# Access Compliance Report

## Public Rights-of-Way

Intersection ID: 11911	Main Street: W_7TH_ST	Cross Street: N_CHURCH_ST	Location: S
ADA ID: 46AB7955D257	Ramp Type: PerpDiag	Initial Pass/Fail: Fail	Overall Compliance: No
		Severity Score: 12.5

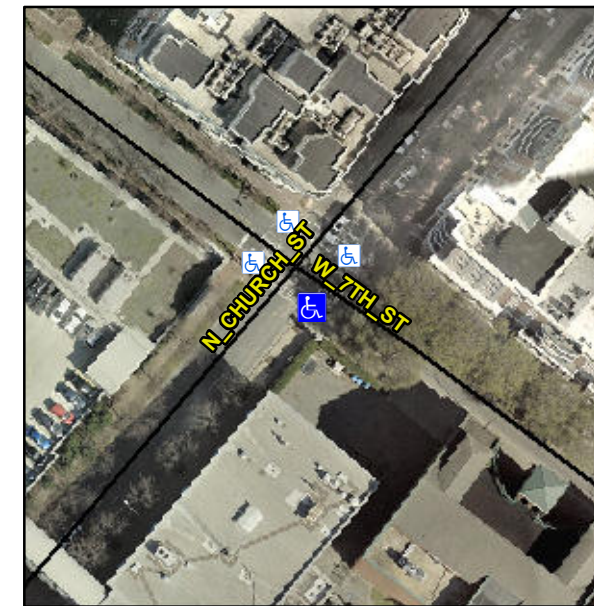
Compliance	Description	Data	Compliance	Description	Data
N/A	Ramp Length (in)	72.0	Yes	Ramp Slope (%)	6.1
Yes	Ramp Width (in)	48.0	No	Ramp XSlope (%)	6.9
N/A	Flare Type LT	N/A	N/A	Flare Type RT	N/A
N/A	Flare Slope LT (%)	N/A	N/A	Flare Slope RT (%)	N/A
N/A	Flare Traversable LT?	N/A	N/A	Flare Traversable RT?	N/A
N/A	Landing Length (in)	N/A	N/A	DWS Provided?	N/A
N/A	Landing Width (in)	N/A	N/A	DWS Contrast?	N/A
N/A	Landing Slope (%)	N/A	N/A	DWS Length (in)	N/A
N/A	Landing X Slope (%)	N/A	N/A	DWS Full Width?	N/A
N/A	Landing Curb? (Y/N)	N/A	N/A	DWS Offset (in)	N/A
N/A	Shared Landing?	N/A			
N/A	Gutter Ponding?	N/A	N/A	Gutter Slope (%)	N/A
N/A	Gutter Lip Ht (in)	N/A	N/A	Gutter X Slope (%)	N/A
N/A	Painted X Walk1?	Yes	N/A	Painted X Walk2?	Yes
	X Walk 1 Direction	To NE		X Walk 2 Direction	To NW
N/A	X Walk 1 Width (in)	109.0	N/A	X Walk 2 Width (in)	86.0
	X Walk 1 Slope (%)	1.3		X Walk 2 Slope (%)	3.2
	X Walk 1 X Slope (%)	0.3		X Walk 2 X Slope (%)	3.9

N/A	Ramp inside XWalk1?	Yes	N/A	Ramp inside XWalk2?	Yes
	Road Slope (%)	9.4	N/A	Clear Space?	N/A
	Road X Slope (%)	1.2	N/A	Clear Space to XWalk (in)	N/A
N/A	Any Obstructions?	N/A	N/A	Storm Grate/Utility Hazard?	N/A
	Obstruction Type			Storm Grate/Utility Type	
		N/A			N/A
		Yes		Surface Condition? (G/P)	Good

**Remove & Replace Curb Ramp With Two New Directional Ramps or Equivalent.**

**R304.5.3**
